MULTIPLE SEWERSHED PACKAGE 10B – OPEN CUT
Solicitation Number: CO-00285-SM
Job No.: 18-4542

ADDENDUM 1
08/23/19

MAP No. 164572 SHEET 2

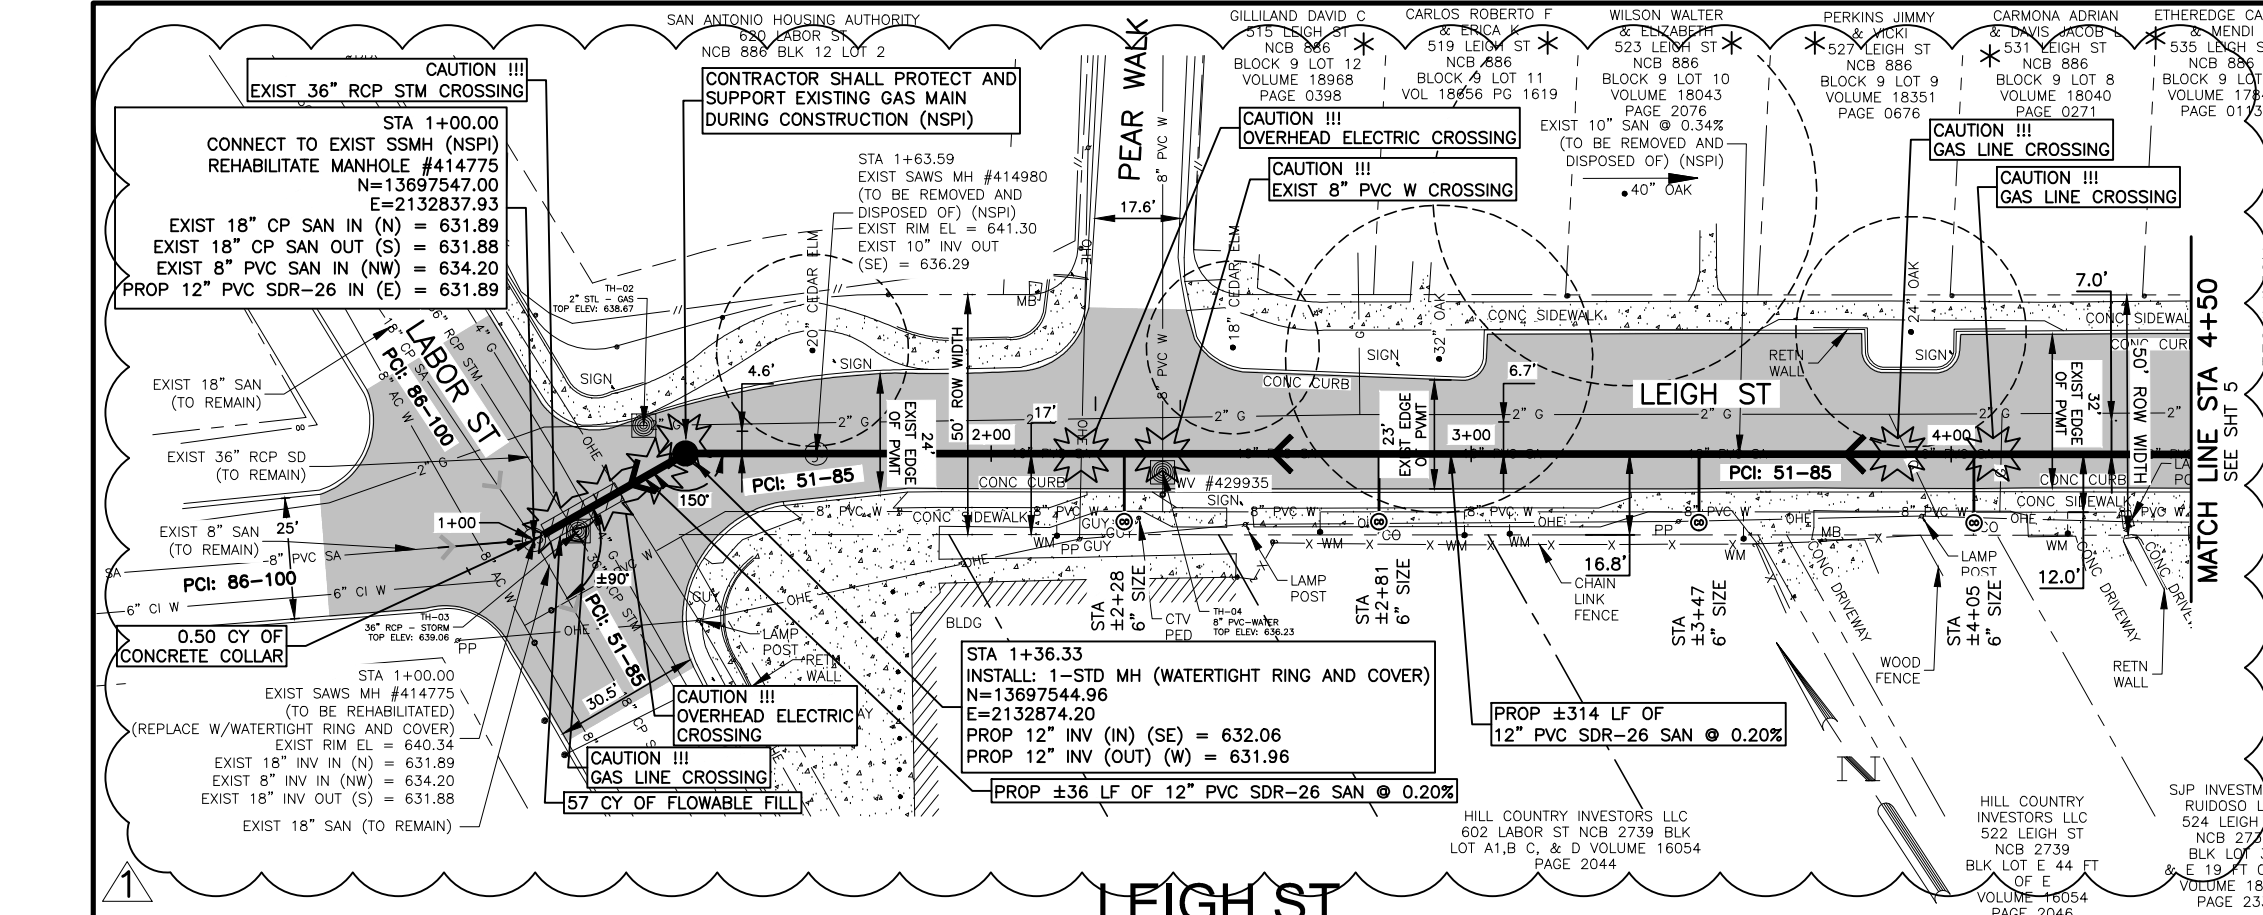
1. DELETE **Sheet 2 of 28** of the SEWER PLANS in its entirety and REPLACE with the attached **Sheet 2 of 28**, dated 8/21/19. Sheet 2 has been revised to add Item 804 COSA Tree Protection to the quantity summary.

SHEET 4 OF 28

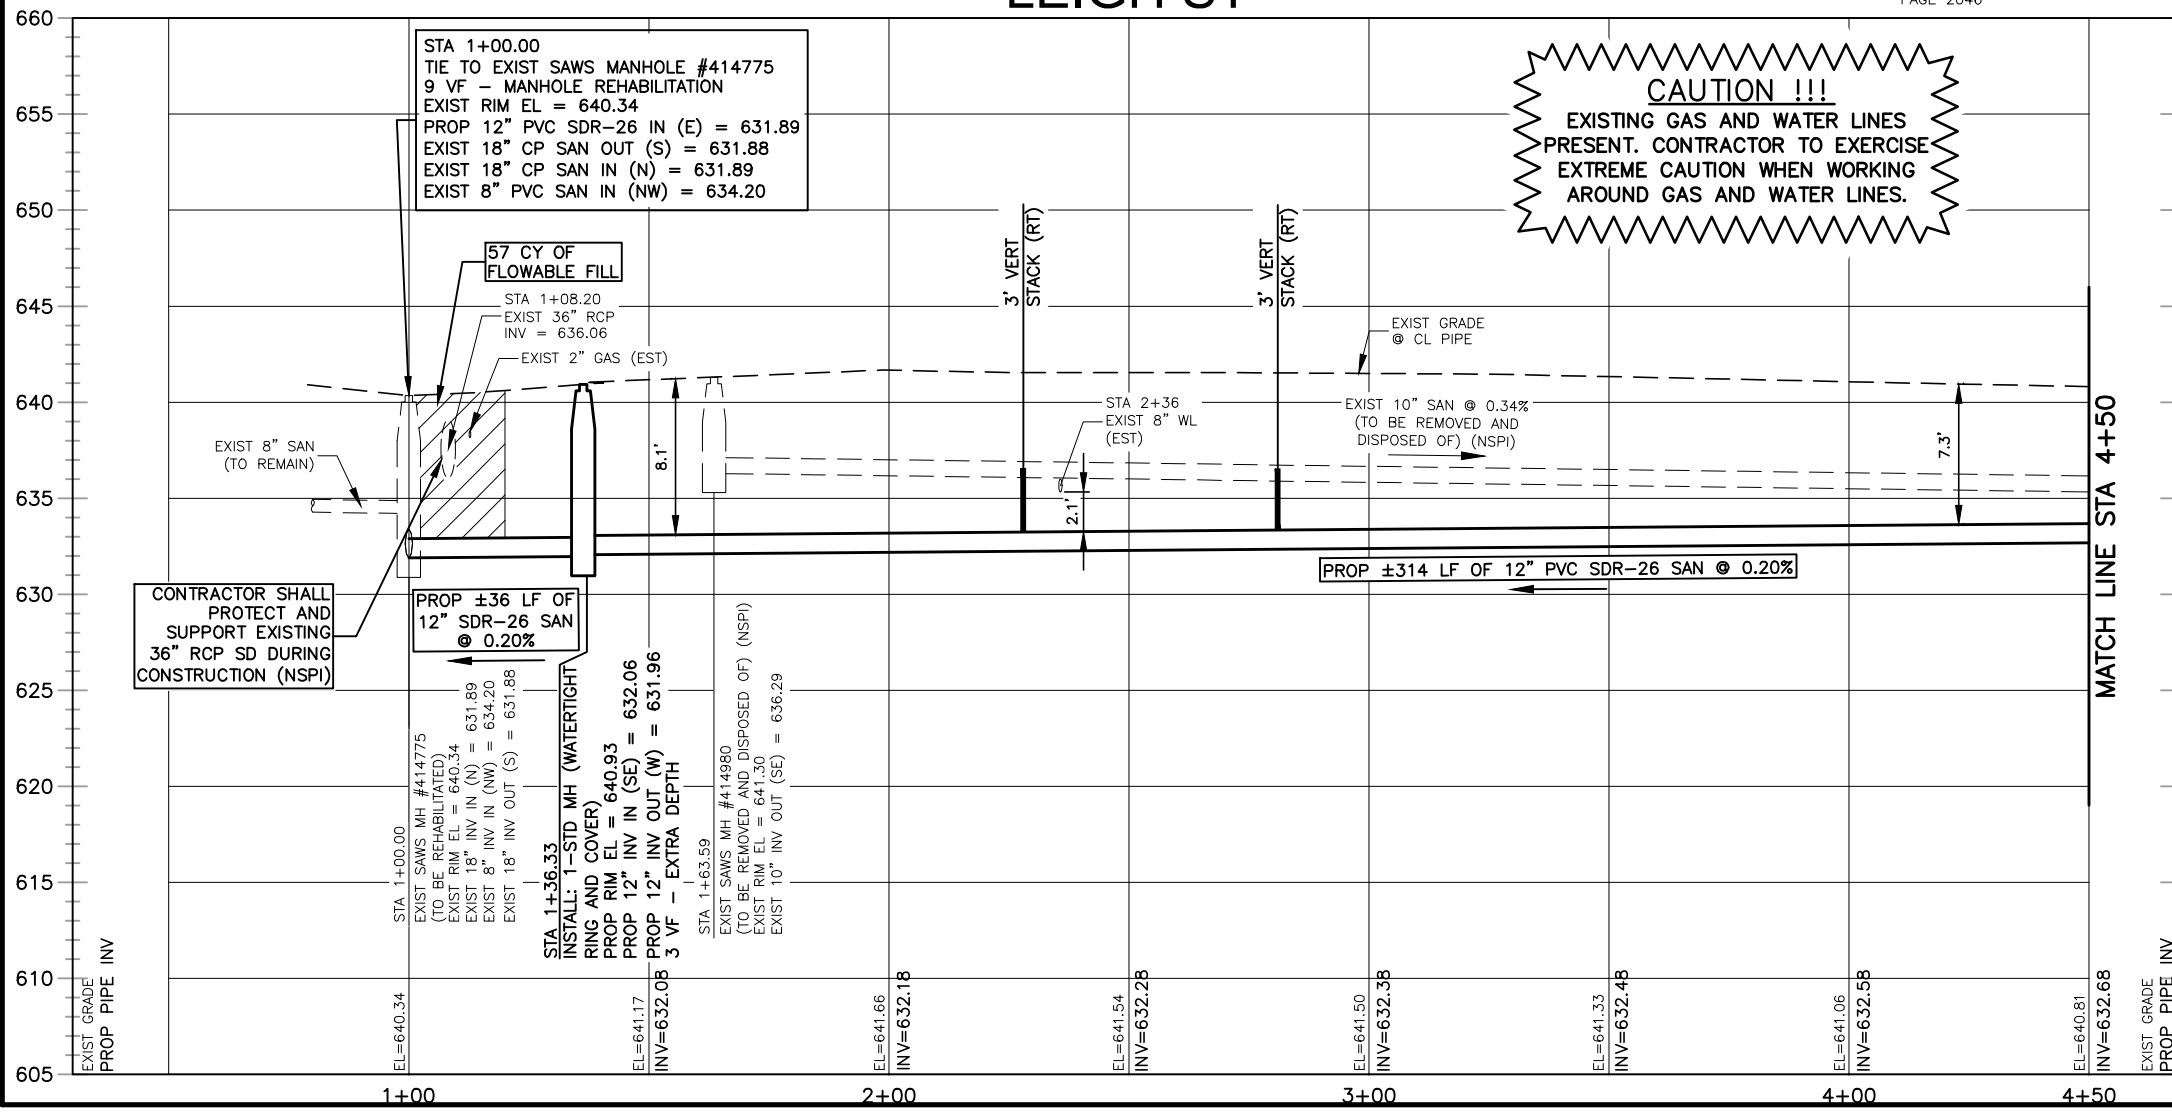
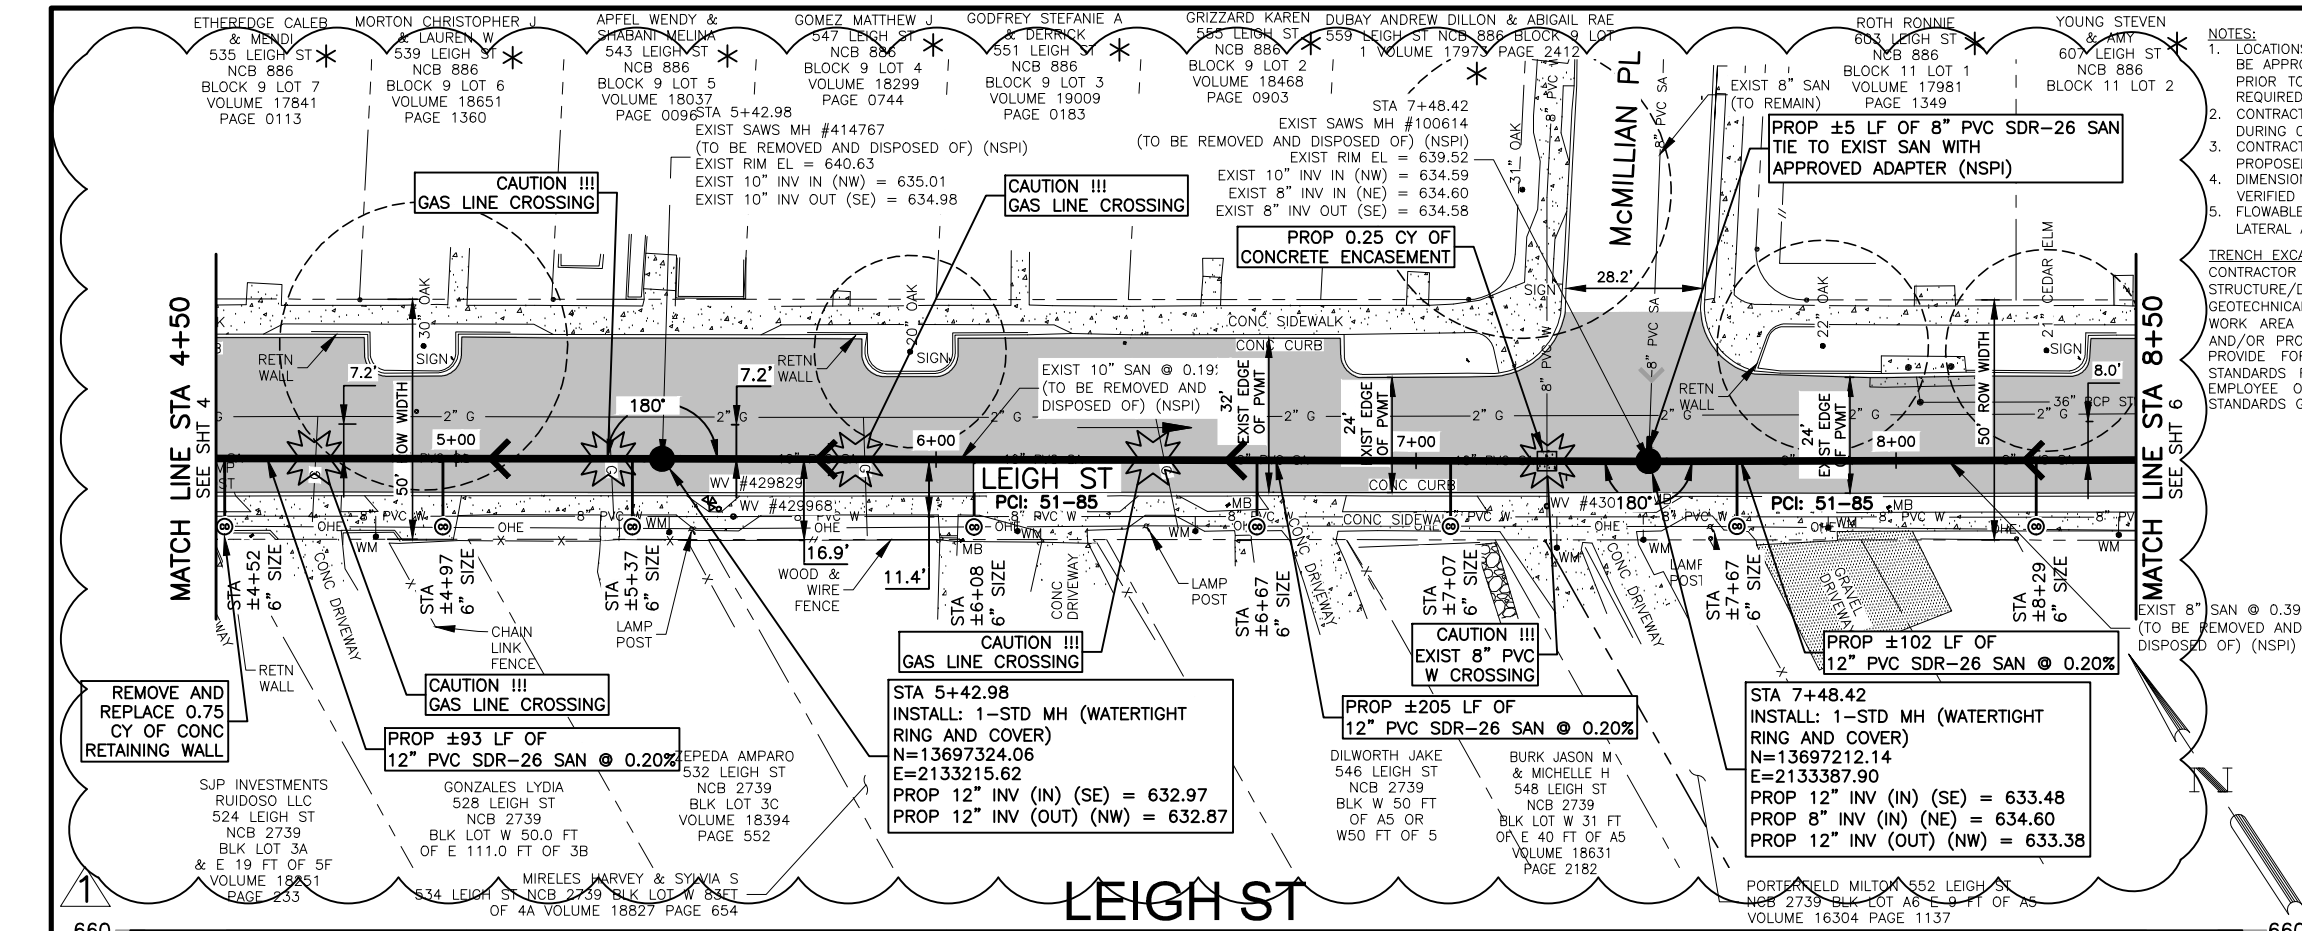
2. DELETE **Sheet 4 of 28** of the SEWER PLANS in its entirety and REPLACE with the attached **Sheet 4 of 28**, dated 8/21/19. Sheet 4 has been revised to show SUE test holes and updated 2" gas line location.

LEIGH SANITARY IMPROVEMENTS STA 4+50 TO STA 8+50

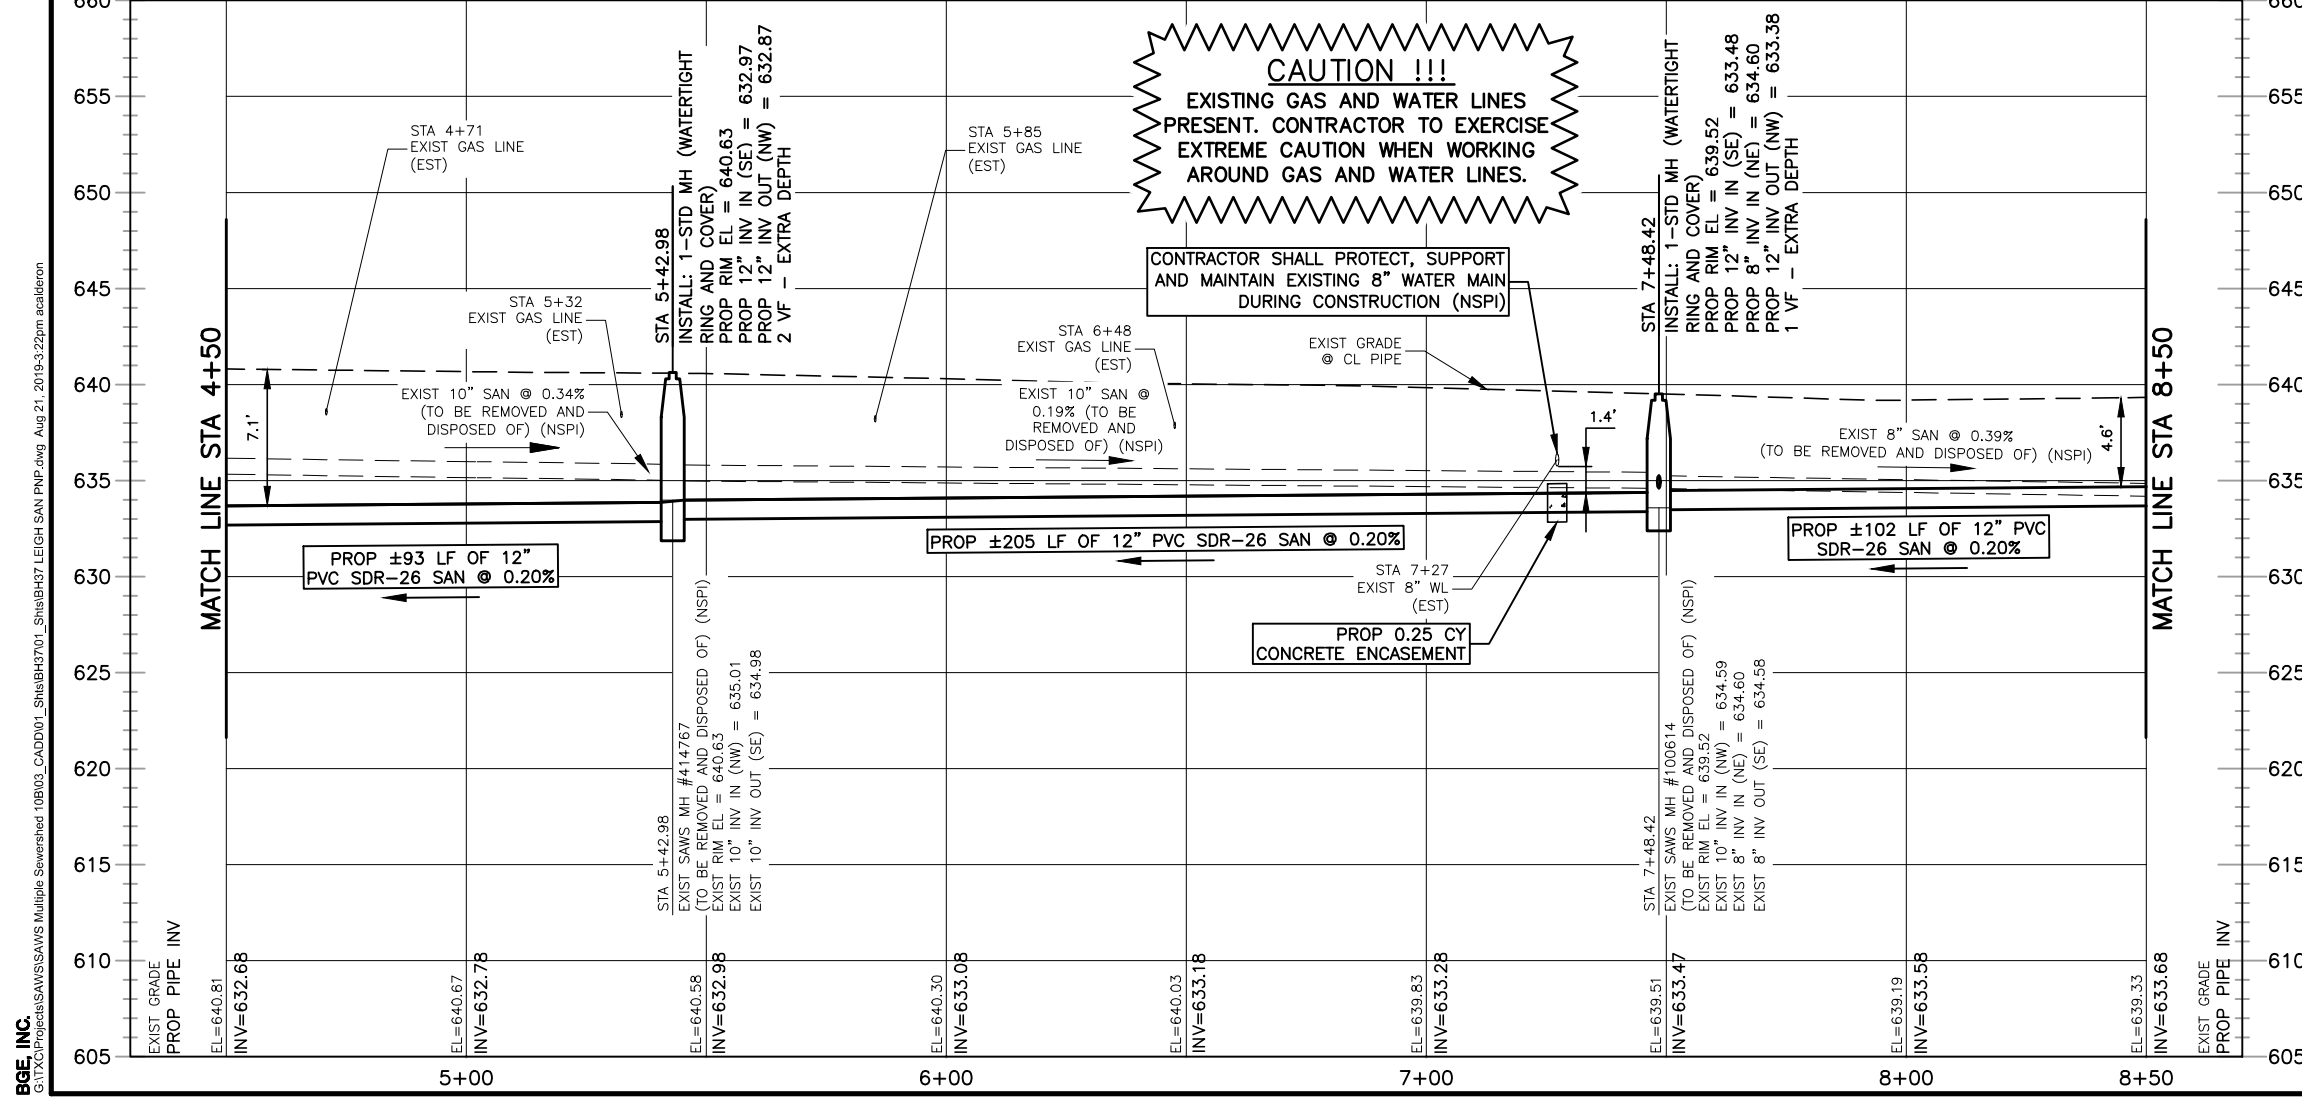
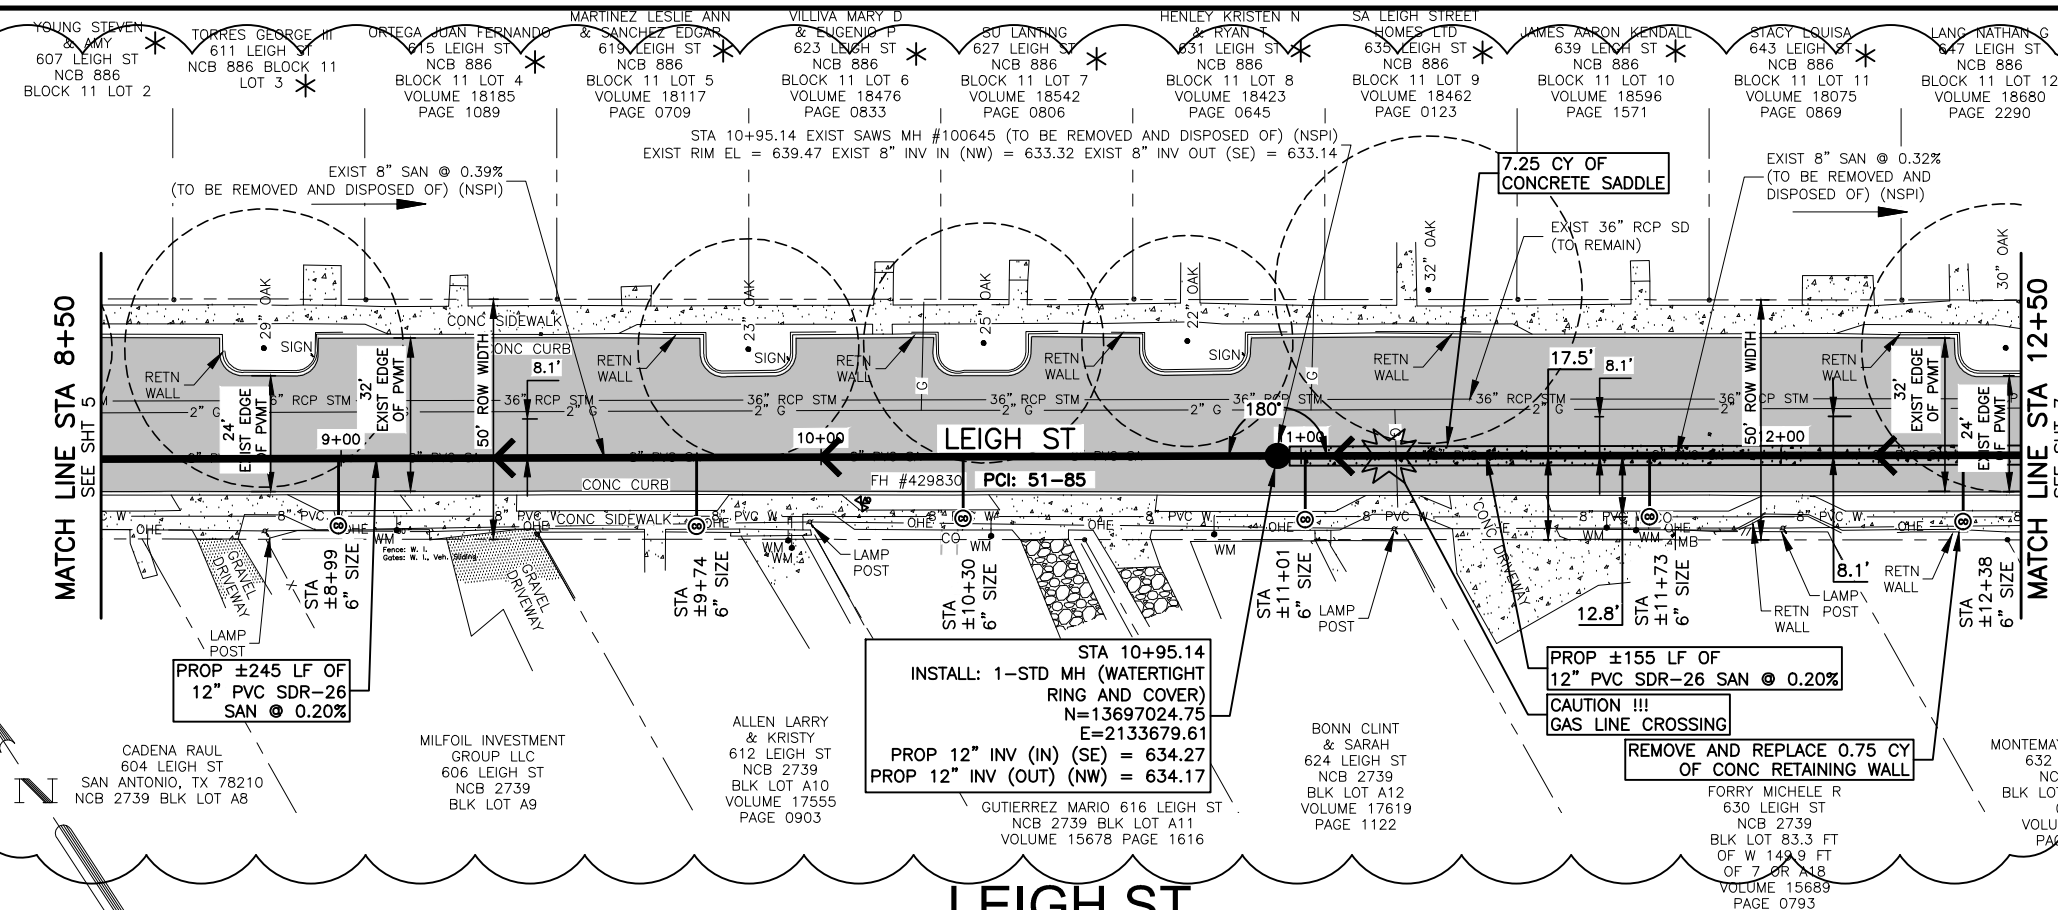
3. DELETE **Sheet 5 of 28** of the SEWER PLANS in its entirety and REPLACE with the attached **Sheet 5 of 28**, dated 8/21/19. Sheet 5 has been revised to show updated 2" gas line location.
